## ADDENDUM

**ADDENDUM NO.:** 04  
**PROJECT NAME:** Emiliano Zapata Academy Annex  
**PROJECT NO.:** 05055  
**CONTRACT NO.:** C1580  
**DATE OF ISSUE:** September 1, 2017

### NOTICE OF CHANGES, MODIFICATIONS, OR CLARIFICATIONS TO CONTRACT DOCUMENTS

SITE DEMOLITION PLAN

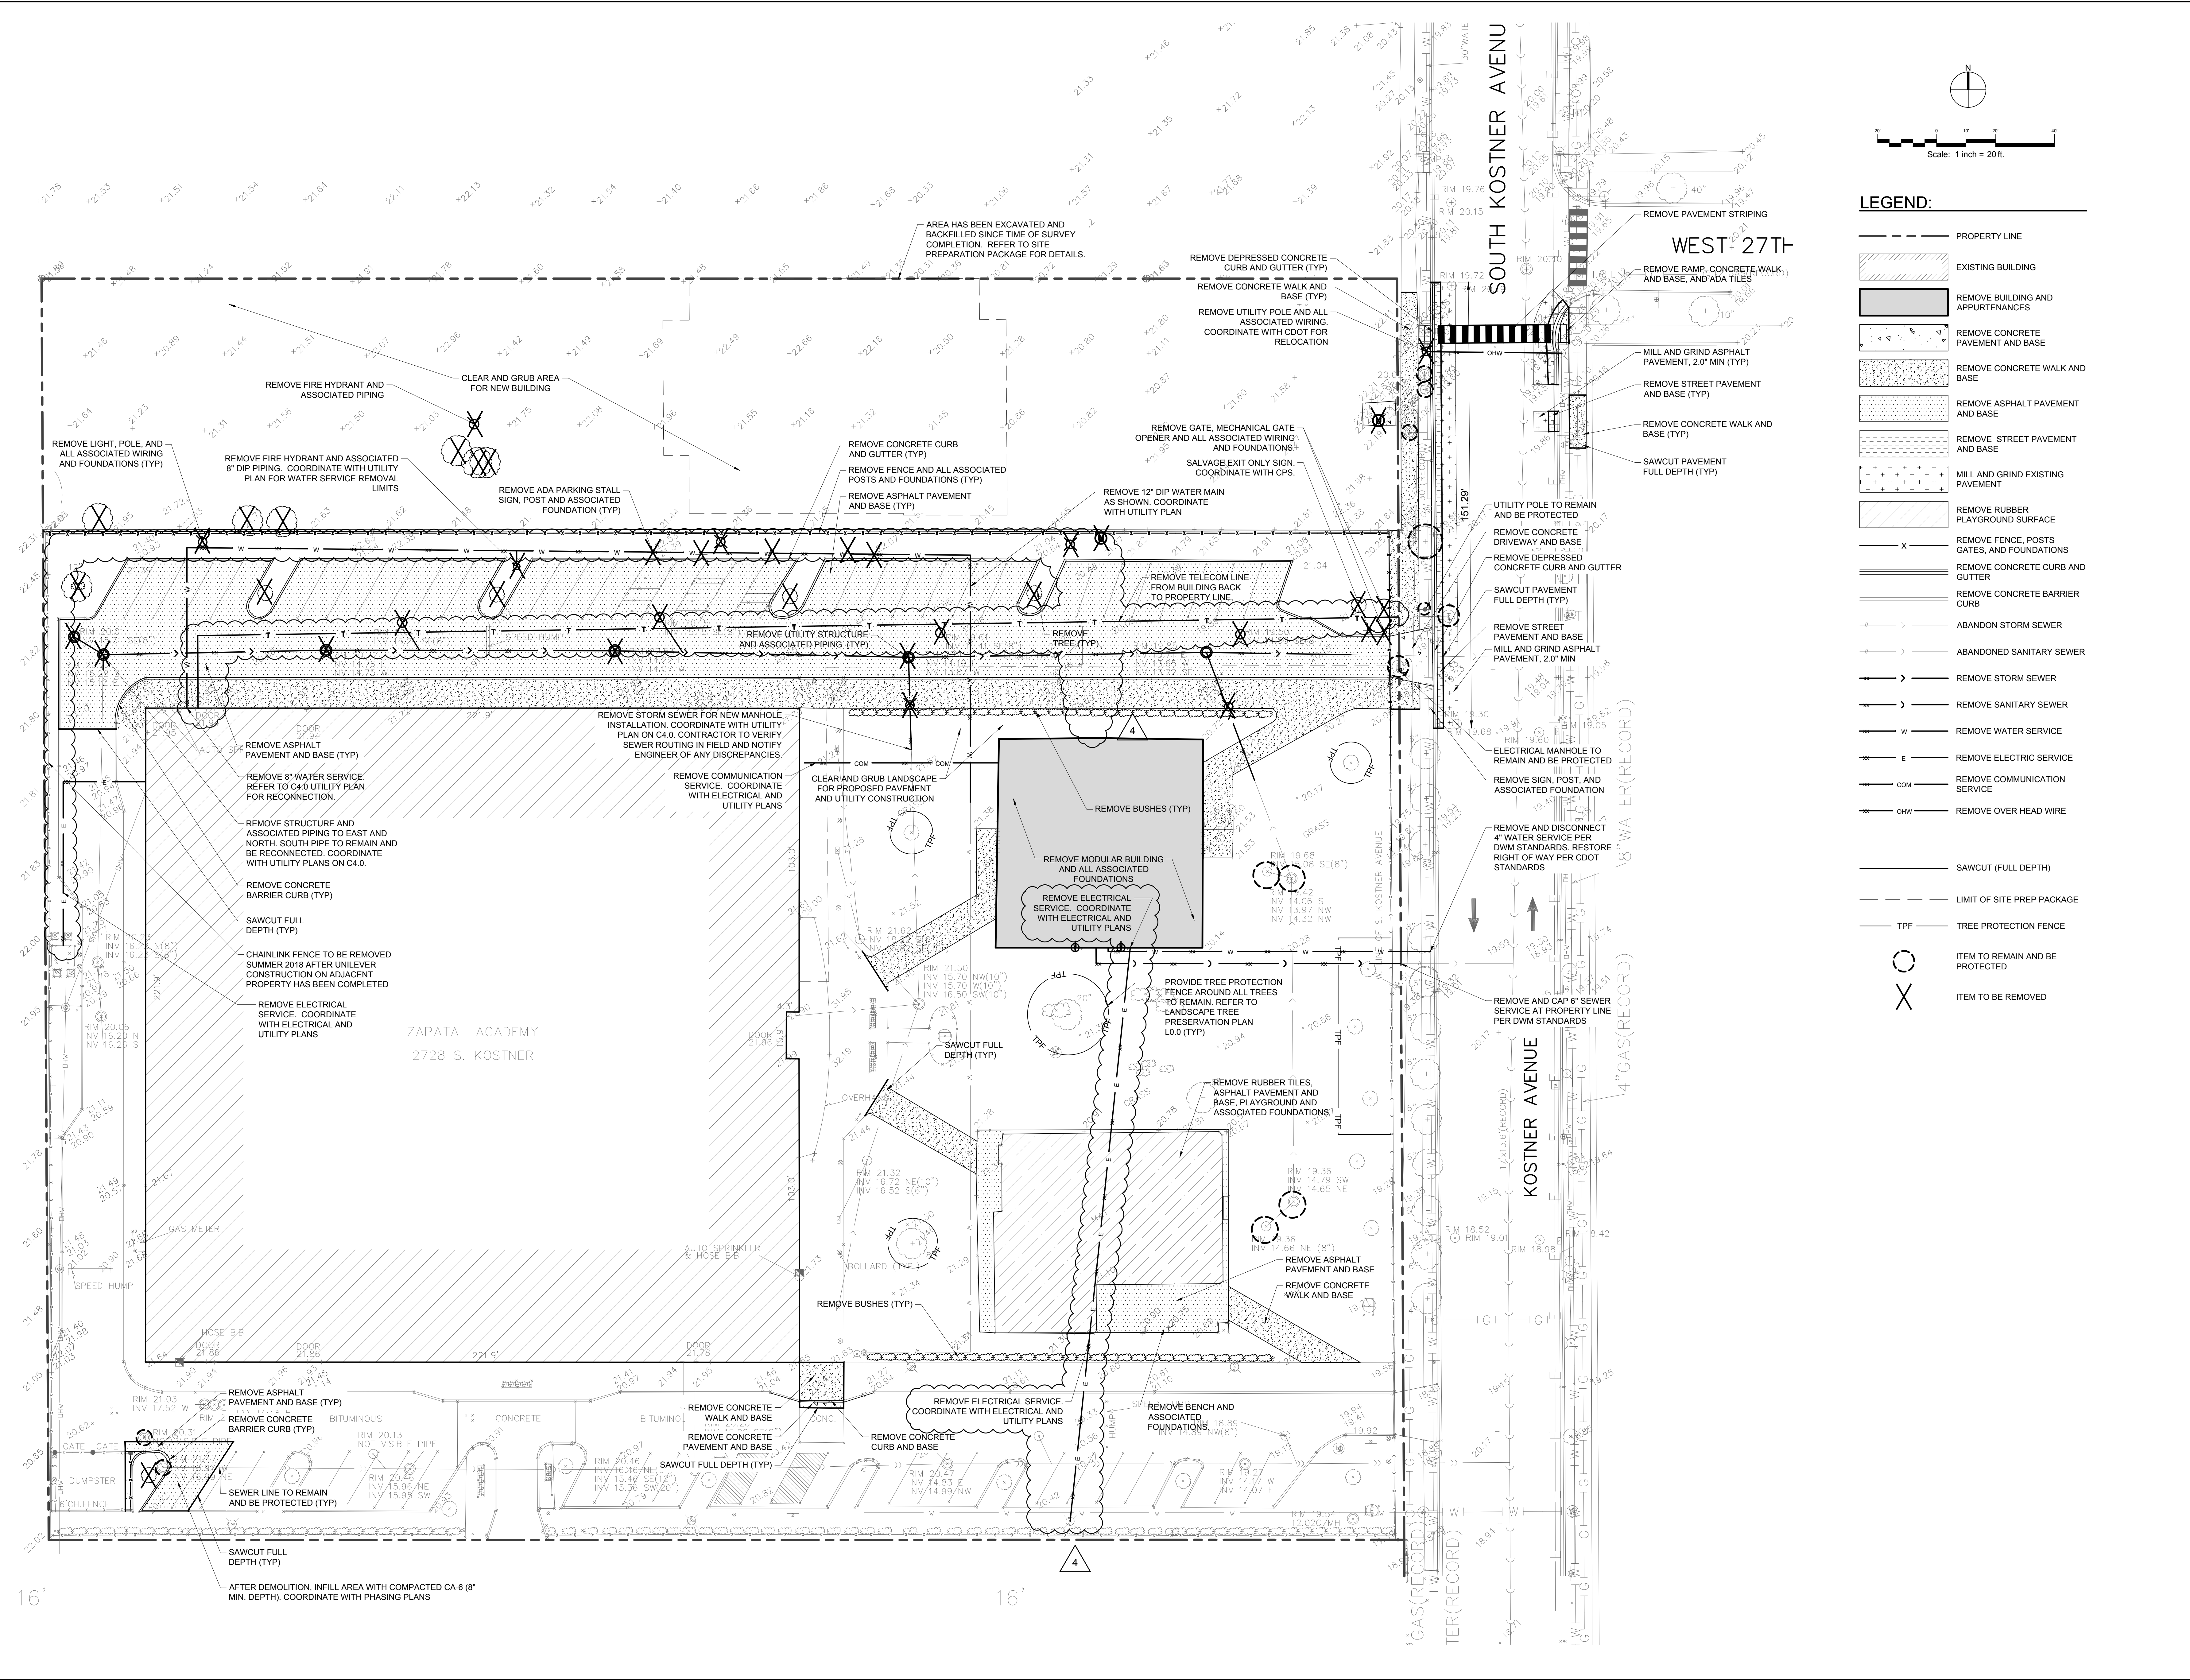
- Change 3.** SHEET C1.0 Site Demolition Plan – **REVISED** existing electrical service path from Modular Building.
- Change 4.** SHEET C4.0 Site Utility Plan (Base Bid) – **REVISED** sewer and water notes and new telecommunications duct bank extents.

**Question:** Is the modular building to be in use during phases 1-6? On drawing C1.0 it is shown to remove the electrical service to the building. How will new power be provided?

**Response:** Please see revised sheet C1.0 for location of power to modular. C1.0 is included in this addendum.

**C4.0A**

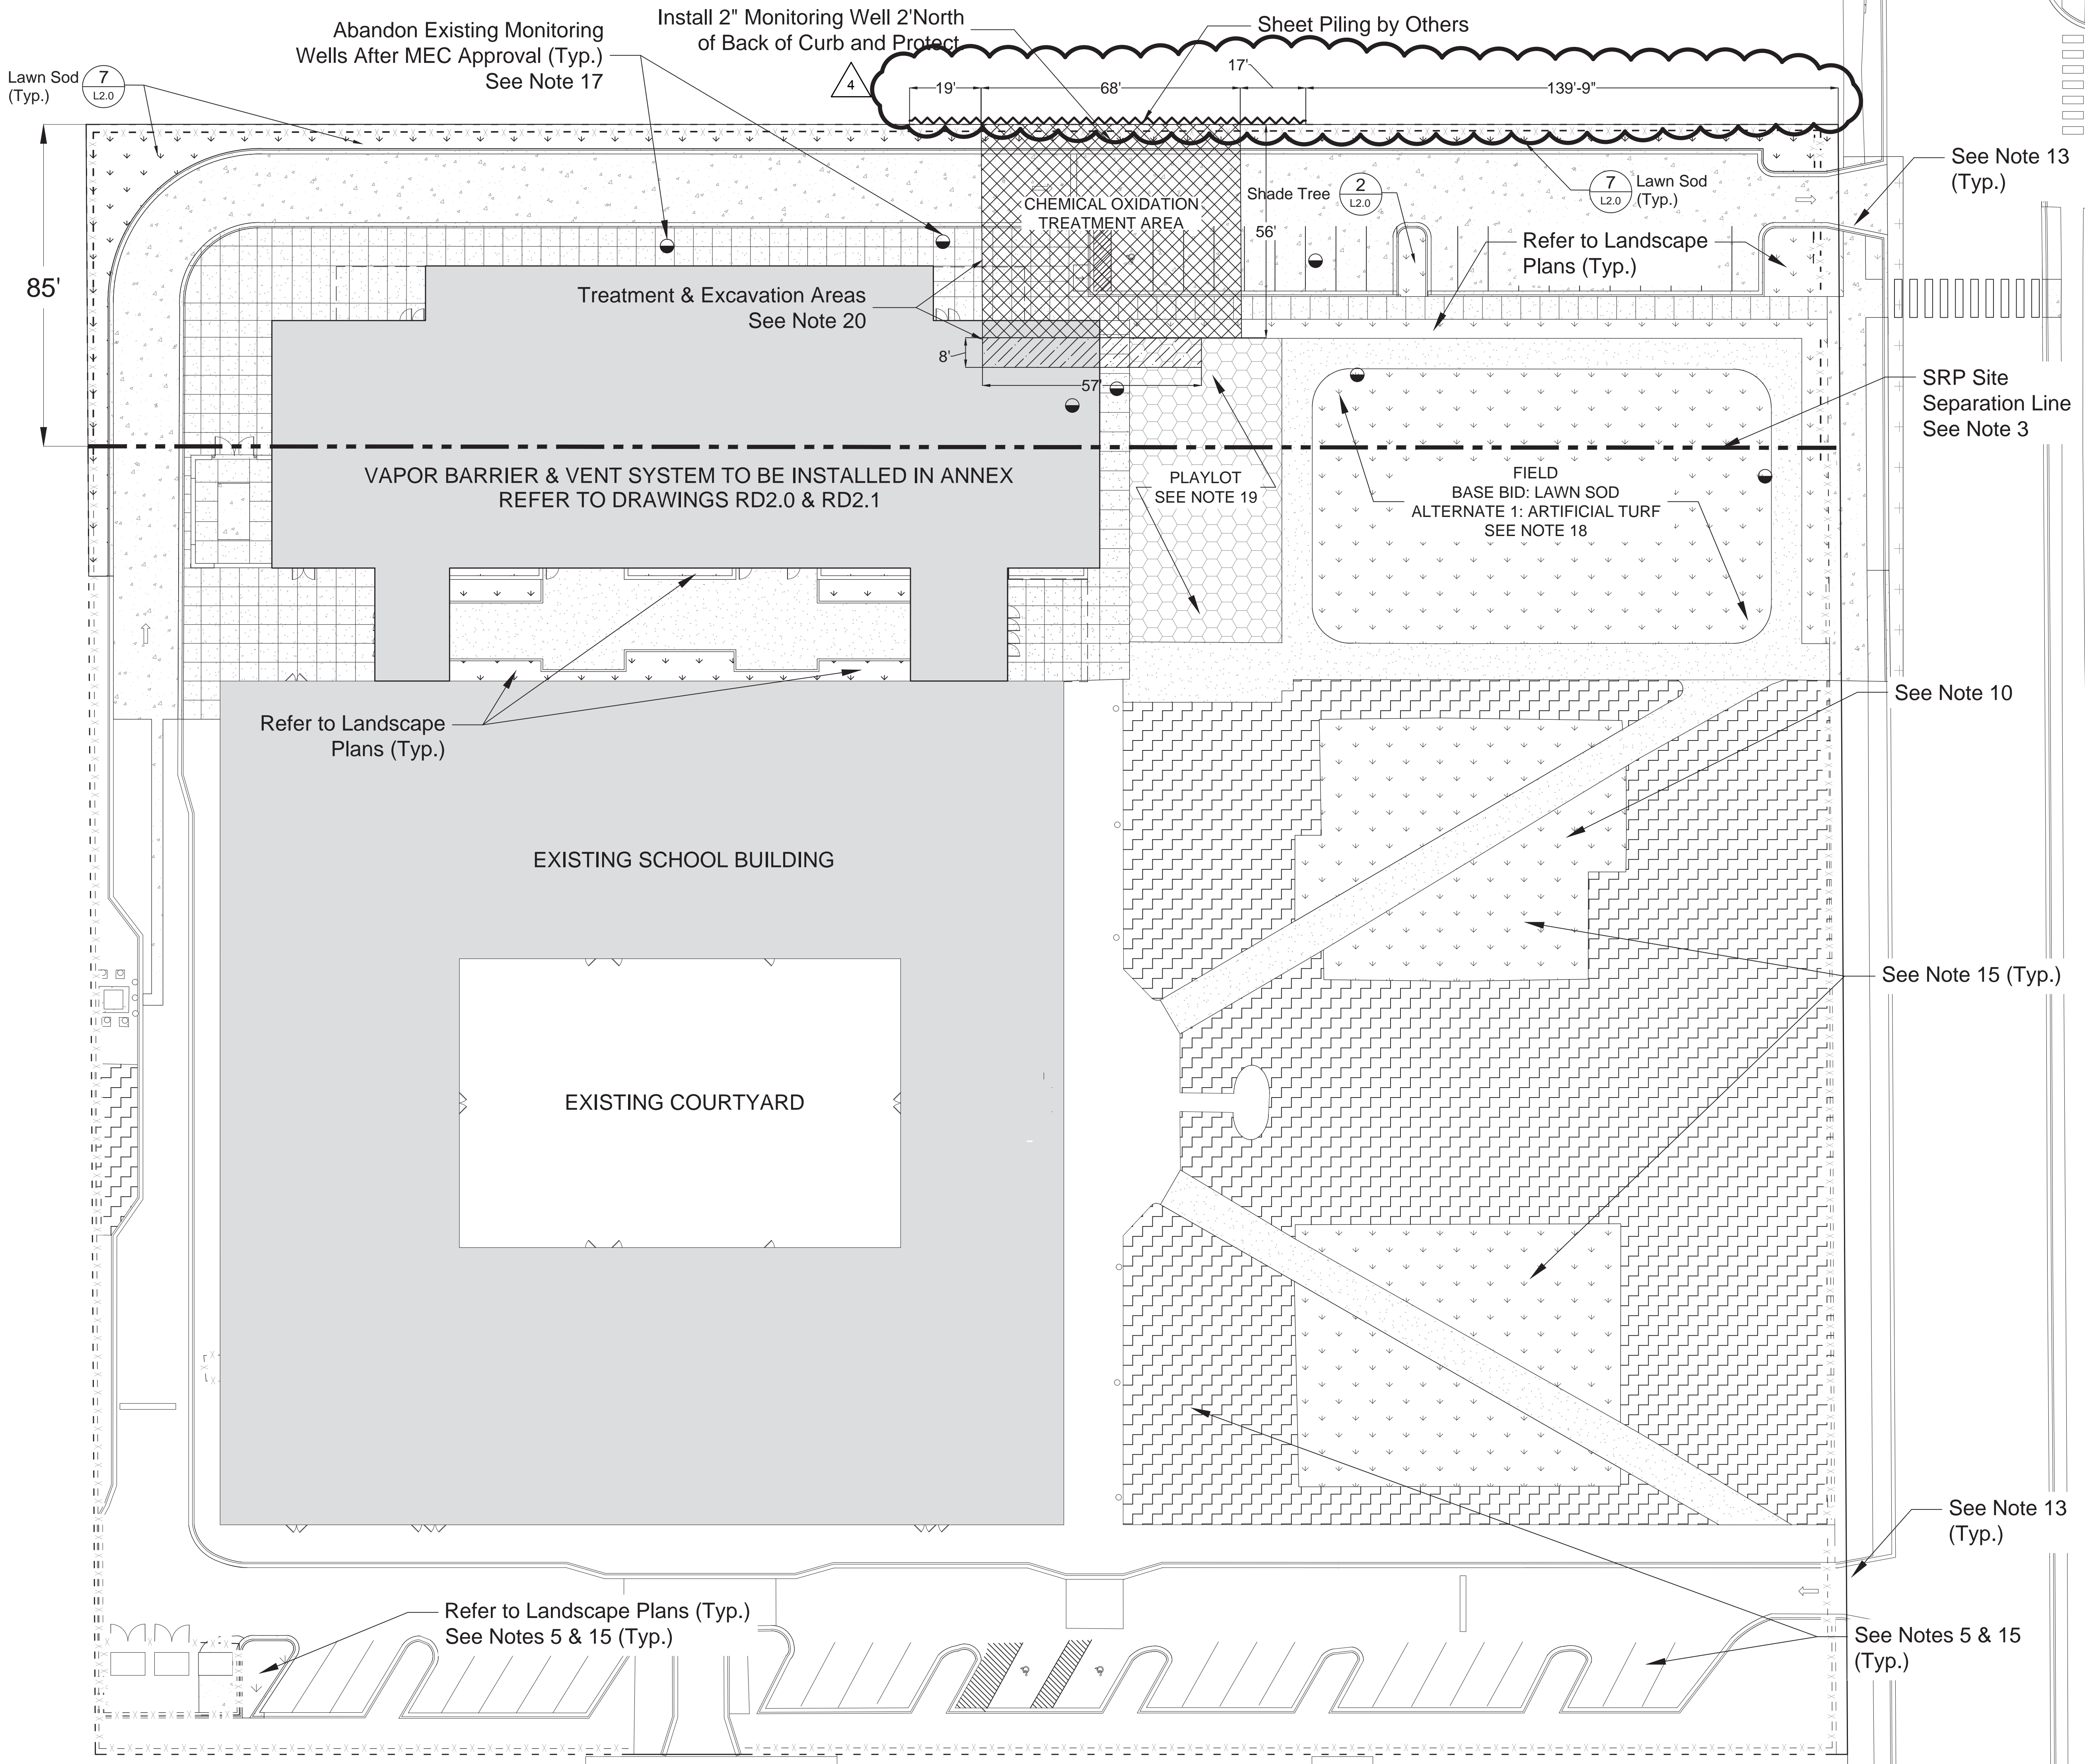
- Change 5.** SHEET C4.0A Site Utility Plan - **REVISED** sewer and water notes and new telecommunications duct bank extents.
- Change 6.** SHEET RD1.0 Remediation Plan – **REVISED** Dimensions of sheet pile wall location and extents, that is being provided and installed by others.

ARCHITECTURAL SITE REMEDIATION PLAN  
AS1.0 1" = 20'

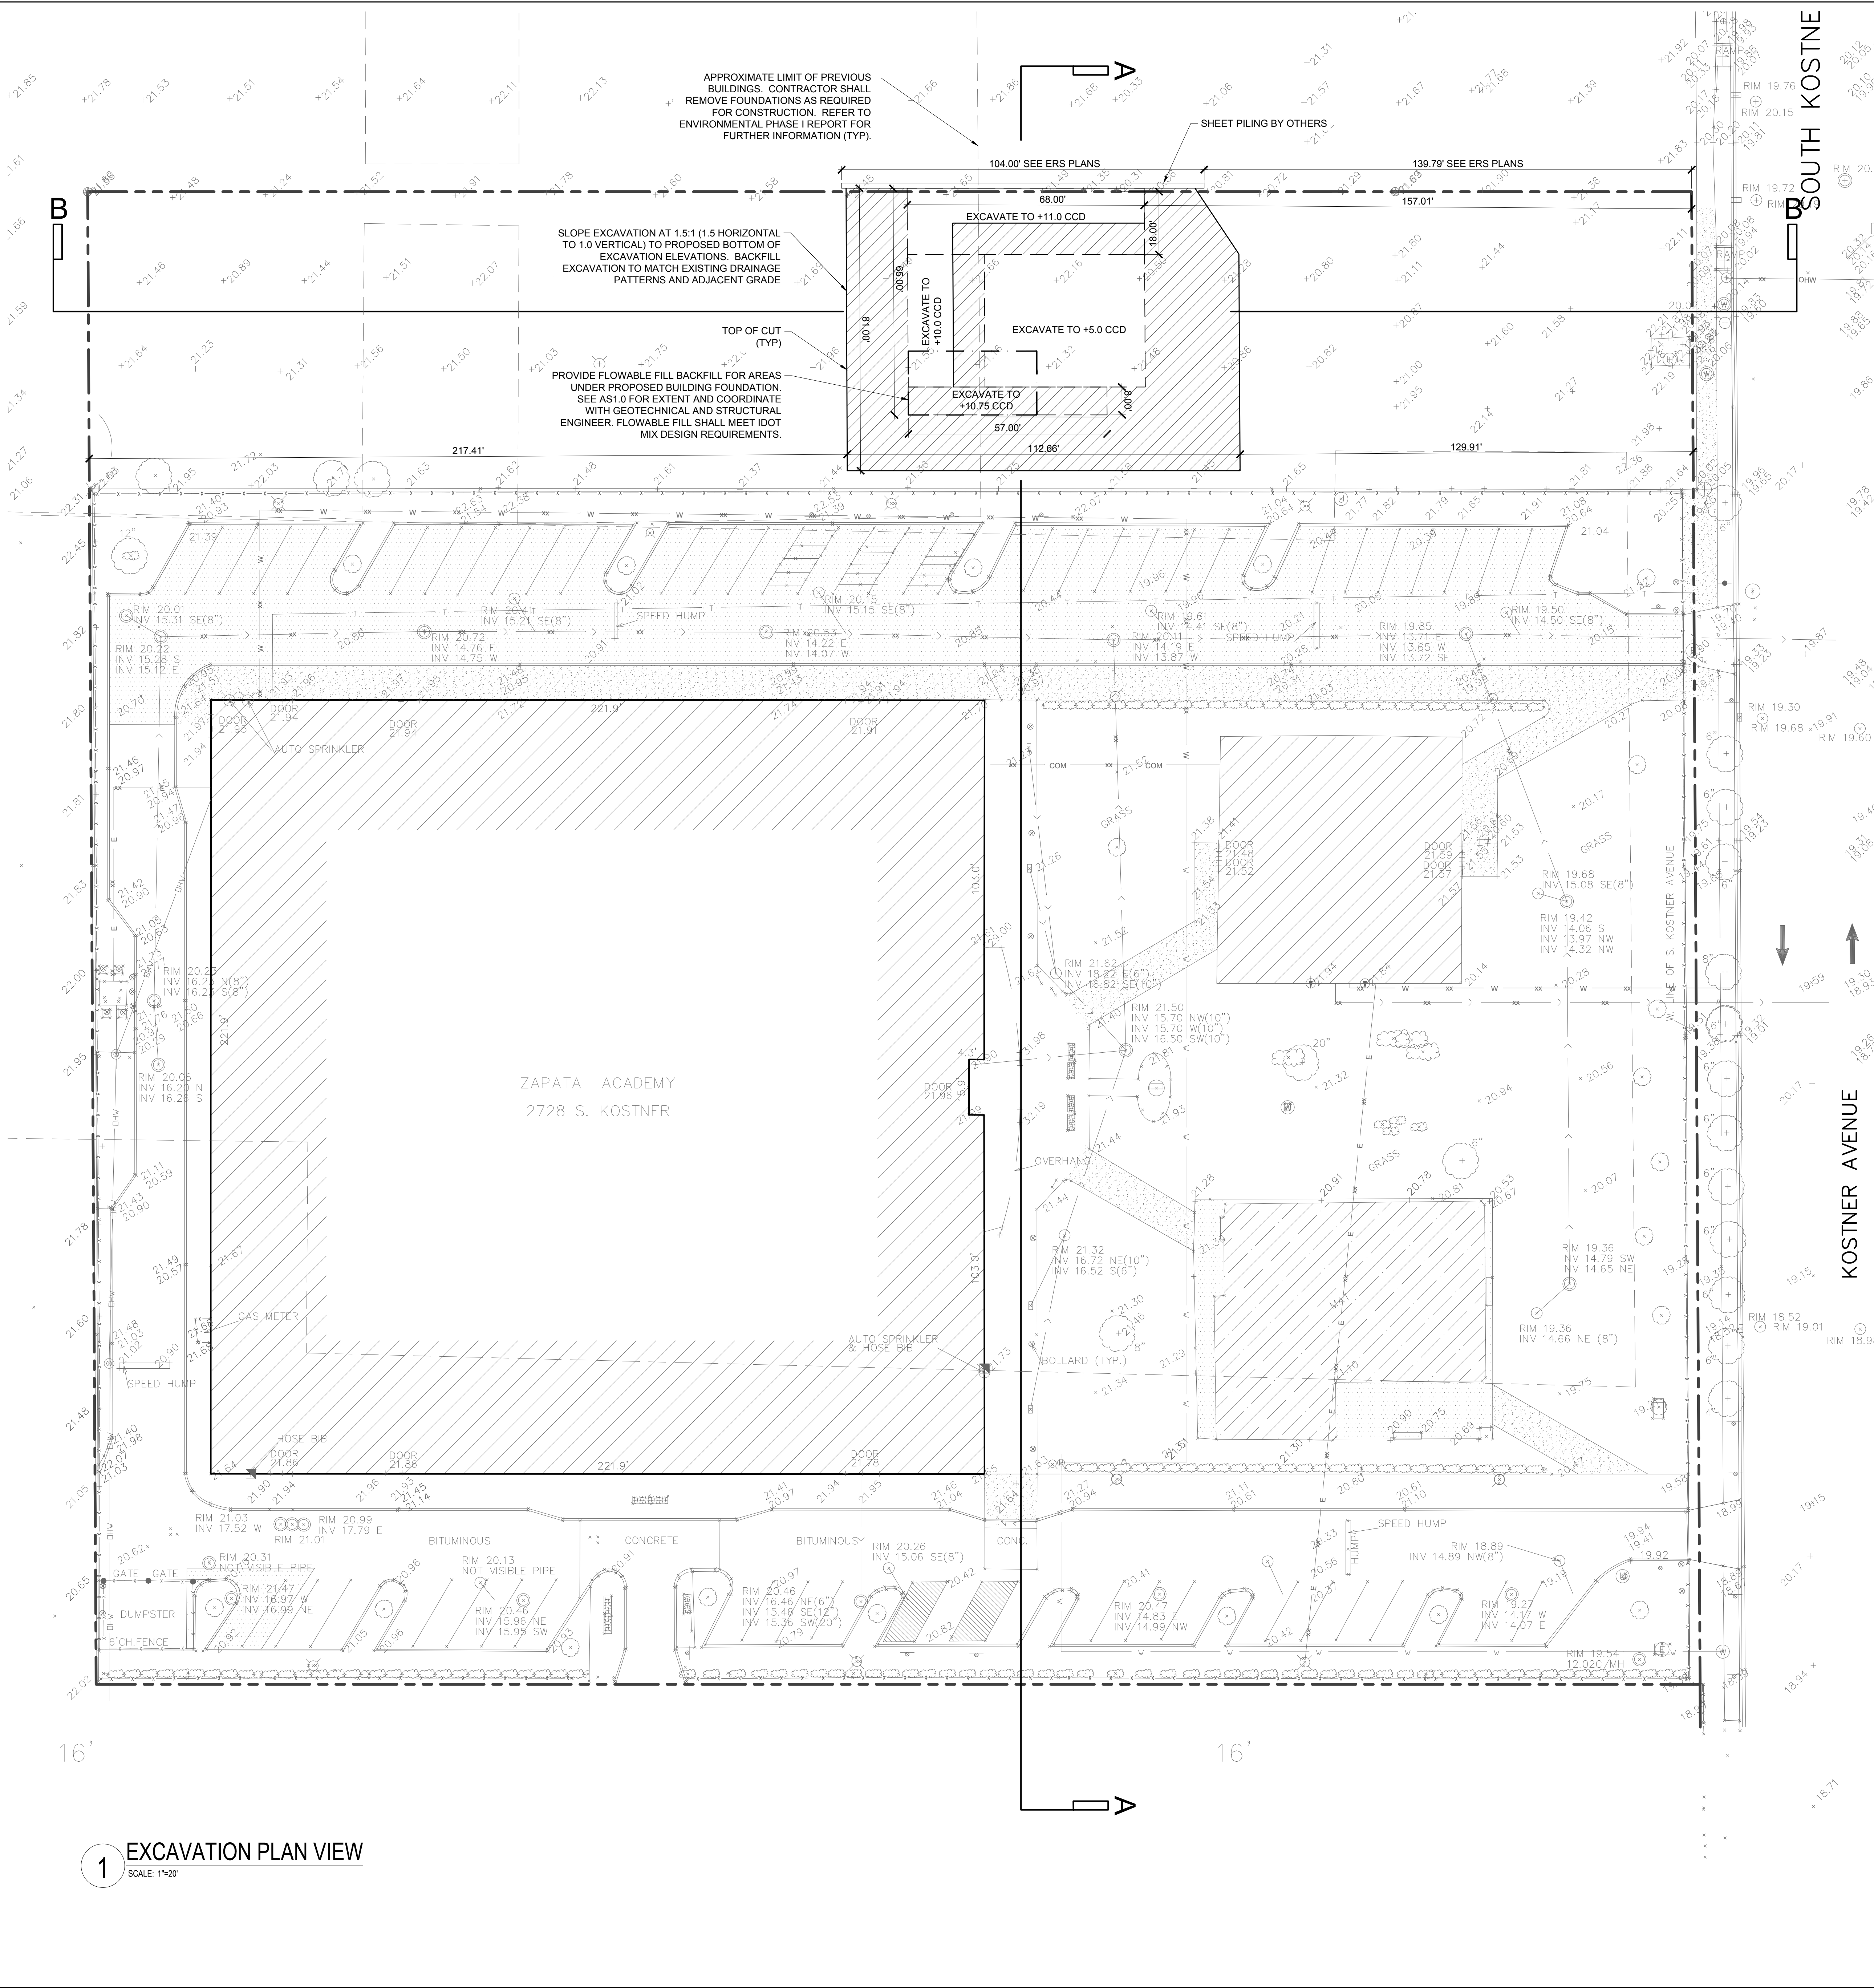
- Change 7.** SHEET AS1.0 – **REVISED** Plan note to reference backfill requirements under building foundations within environmental remediation area.
- Change 8.** SHEET ERS1.0 – **DELETED** sheet. Information from sheet is now provided on sheet EX1.0 Excavation Plan.
